## CERTAIN 2004 THROUGH 2006 MODEL YEAR F-150 AND 2006 MODEL YEAR MARK LT VEHICLES — CLOCKSPrING TO DRIVER SIDE FRONTAL AIR BAG WIRE HARNESS REPLACEMENT

FIGURE 1

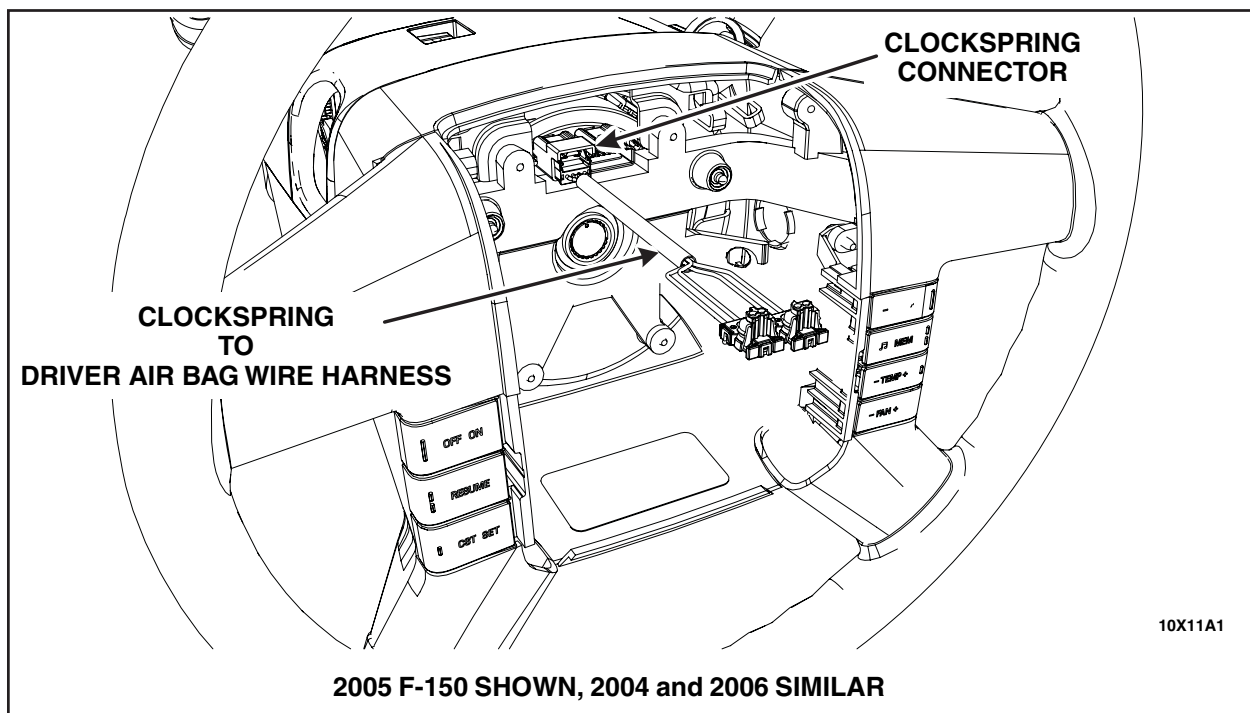
1. Remove the driver air bag. For additional information, refer to the appropriate WSM, Section 501-20B.
2. Release the clockspring connector lock and disconnect the harness from the clockspring. See Figure 1.

3. Install the **new** clockspring to driver air bag wire harness using the following sequence:
  1. Connect the harness to the clockspring.
  2. Make sure the harness lock at the clockspring is seated.
  3. Connect the harness to the air bag.
4. Install the driver air bag. For additional information, refer to the appropriate WSM, Section 501-20B.
